ATTACHMENT B
PAGES REVISED DUE TO PROPOSED AMENDMENT
TO LICENSE/TECHNICAL SPECIFICATIONS

<u>NPF-11</u>	<u>NPF-18</u>
Index page I	Index page I
Index page II	Index page II
Index page XVII	Index page XVII
Index page XVIII	Index page XVIII
Index page XIX	Index page XIX
1-1*	1-1*
1-2 Inserts A and B	1-2 Inserts A and B
1-2a new page	1-2a new page
1-3 Insert C	1-3 Insert C
1-4 Inserts D and E	1-4 Inserts D and E
1-5*	1-5*
1-6 Insert F	1-6 Insert F
1-6a new page	
1-7	1-7 Insert G
1-7a new page	
1-8 Insert G	
1-8a new page	
B 3/4 11-1	B 3/4 11-1
5-15-1	
5-2 DELETE Figure 5.1.1-1	5-2 DELETE Figure 5.1.1-1
5-3 DELETE Figure 5.1.2-1	5-3 DELETE Figure 5.1.2-1
5-4	5-4
6-15 Insert H	6-15 Insert H
6-16	6-16
6-17*	6-17*
6-18*	6-18*
6-19	6-19
6-20	6-20
6-21*	6-21*
6-22*	6-22*
6-23	6-23
6-24	6-24
6-25	6-25 Insert I
6-26 Insert I	6-26
6-27	6-27
6-28*	6-28*

Figure 5.1.2-1

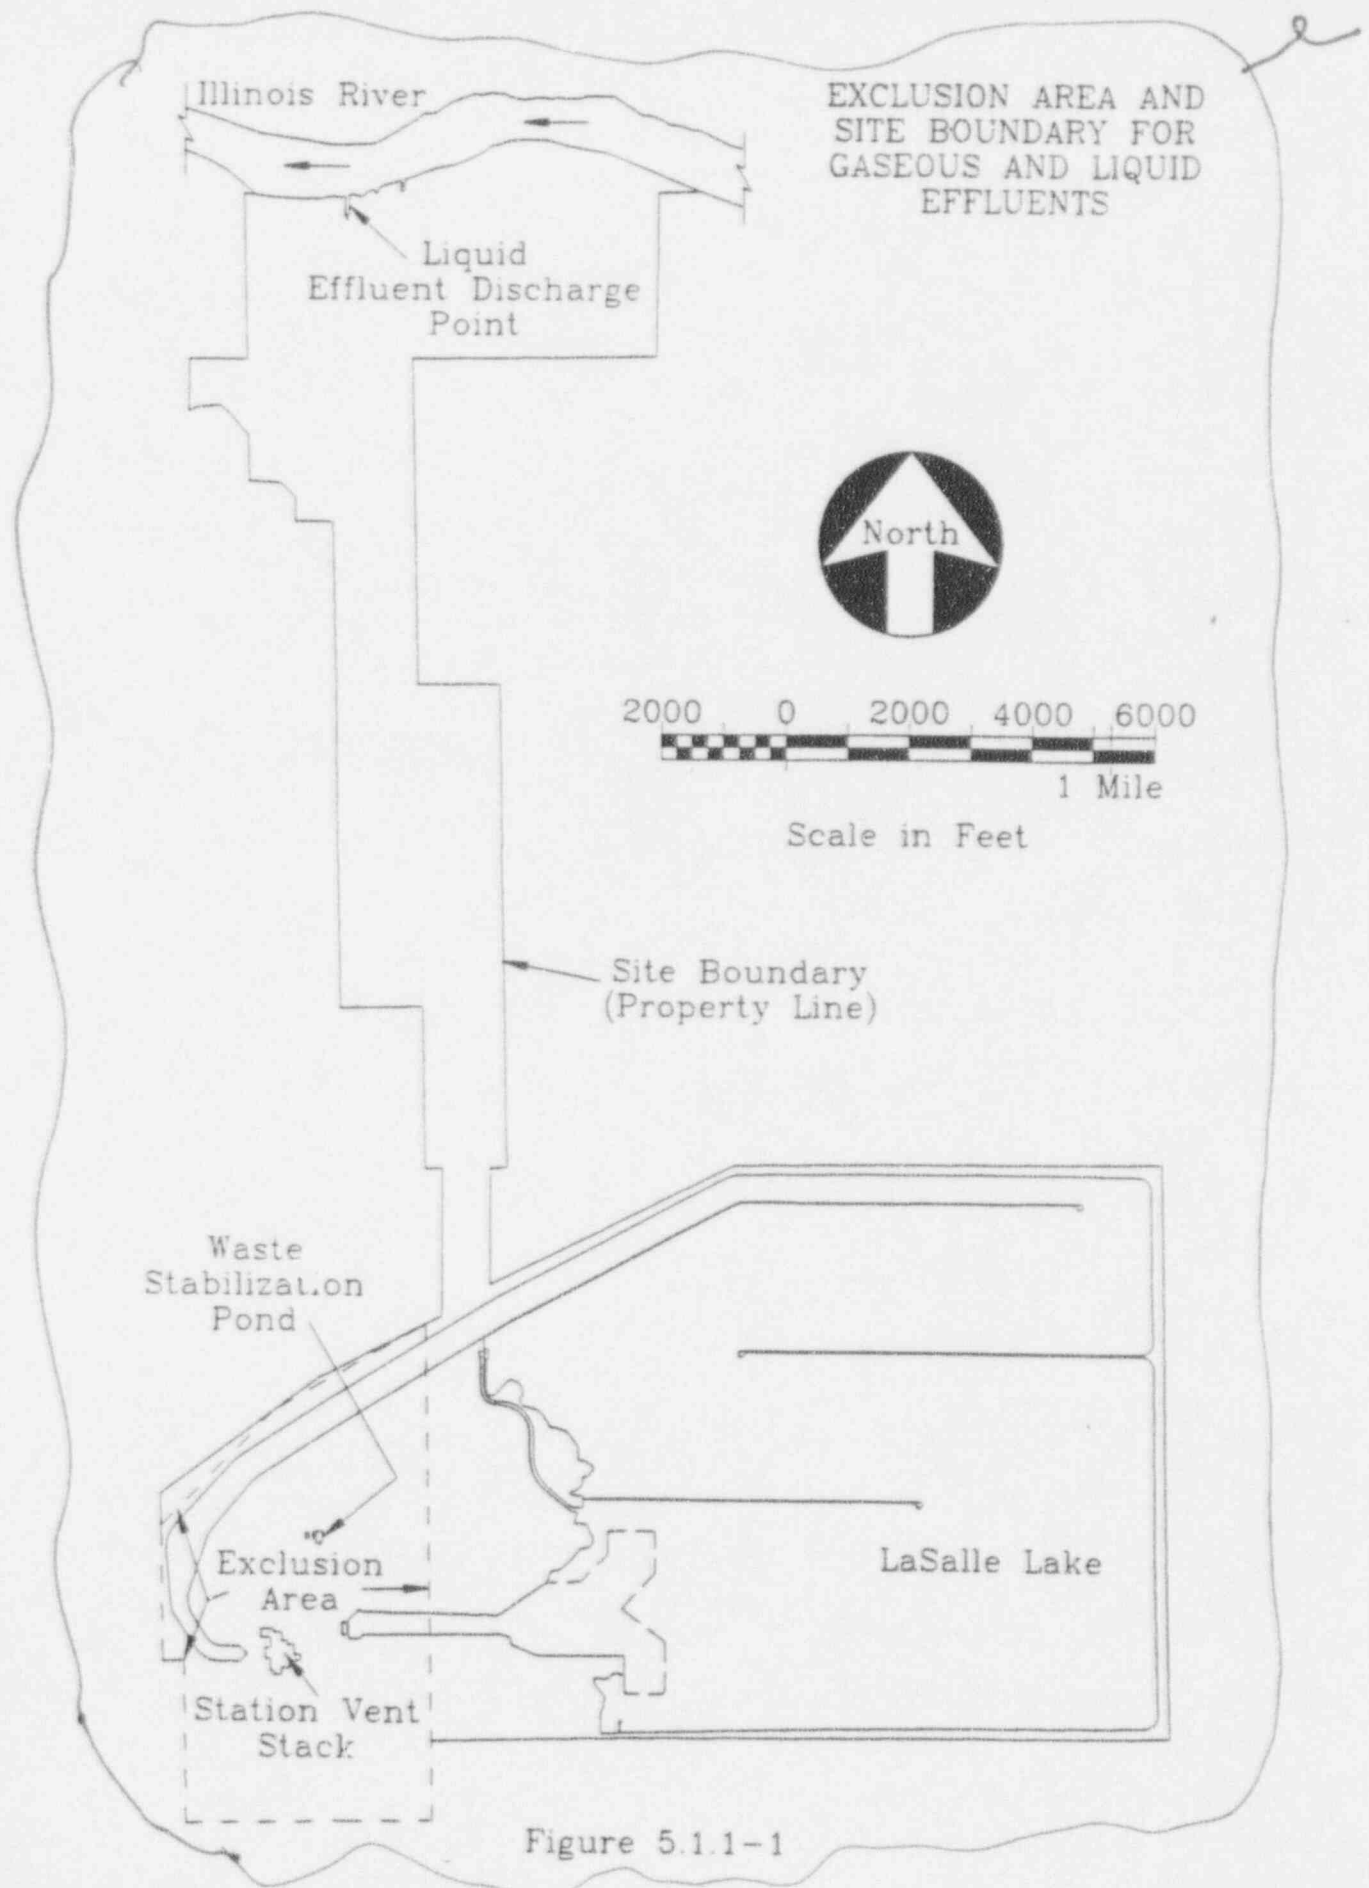
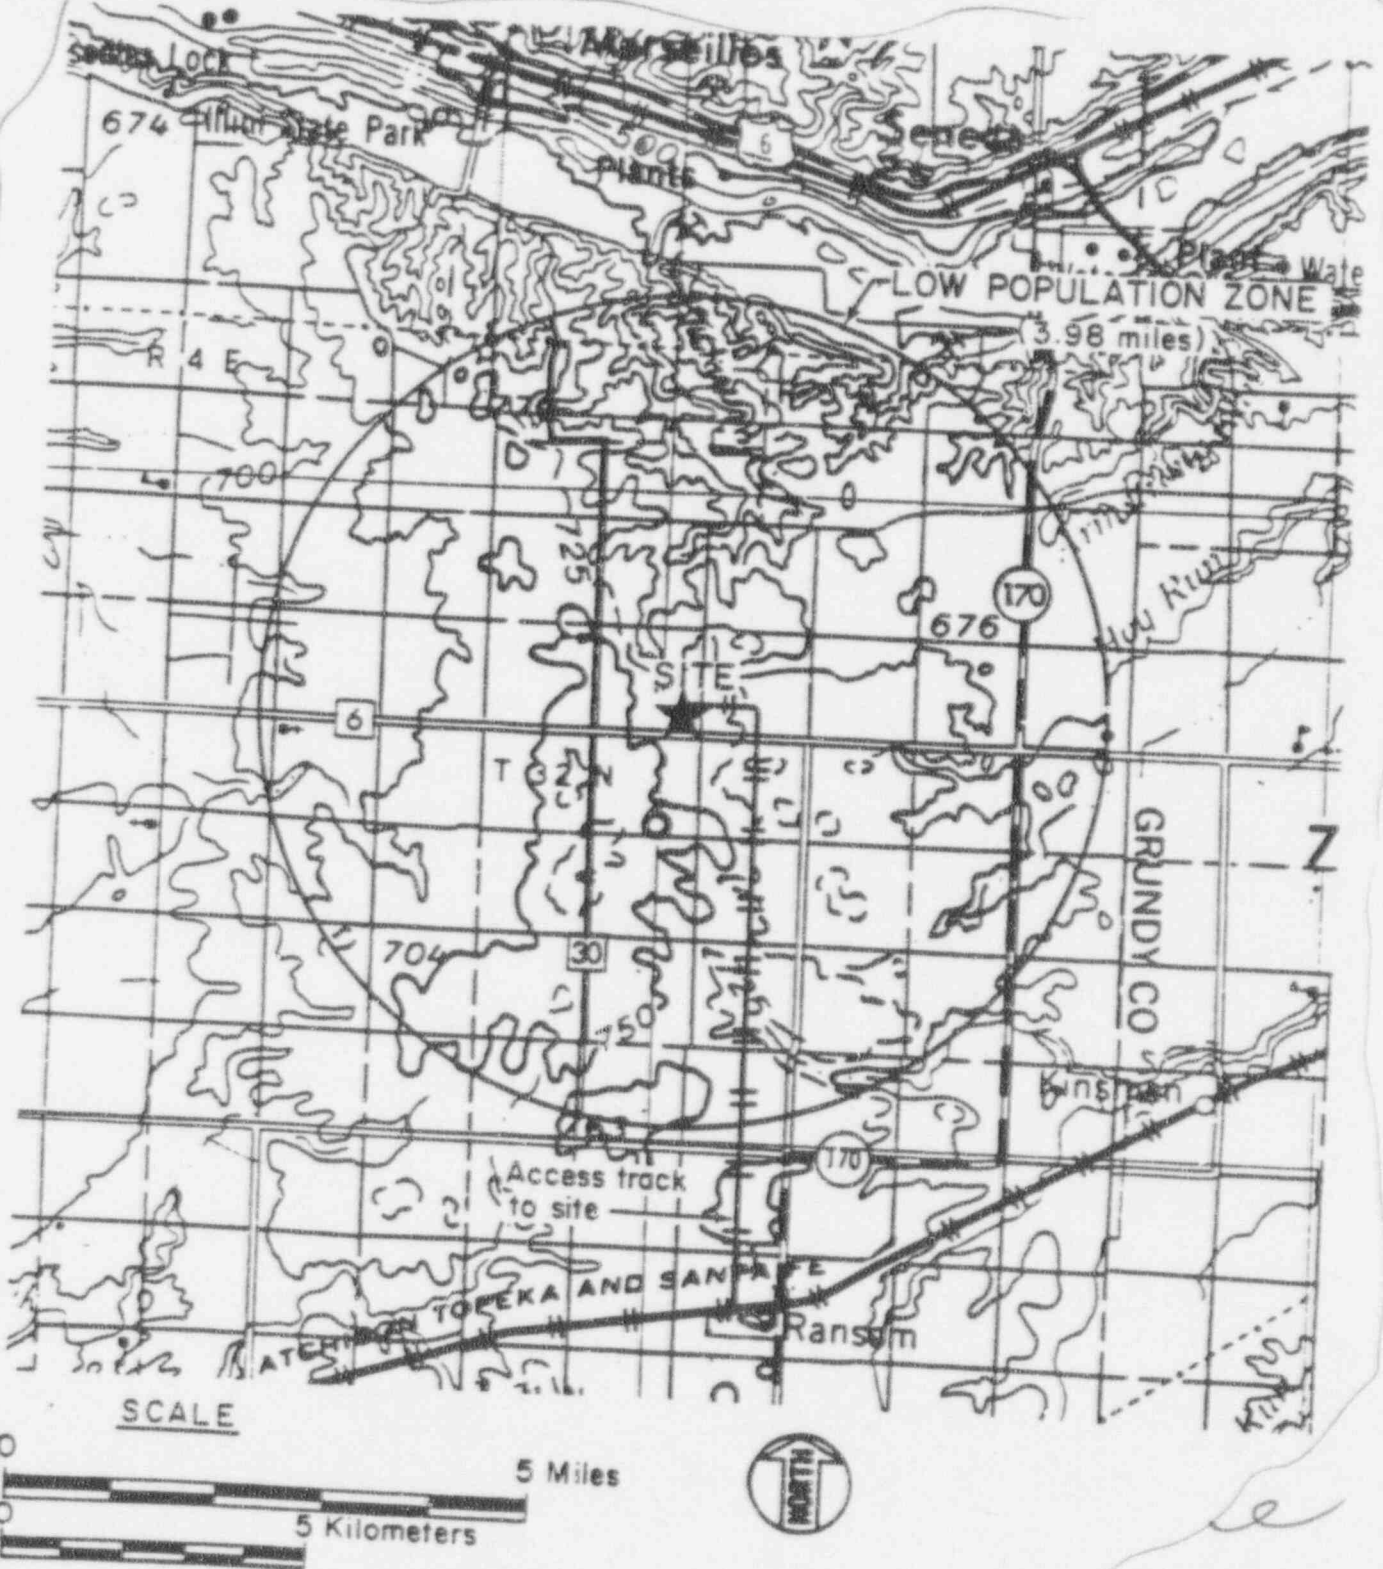
5.1.1 The exclusion area shall be as shown in Figure 5.1.1-1. Deleted

5.1.2 The low population zone shall be as shown in Figure 5.1.2-1. Deleted
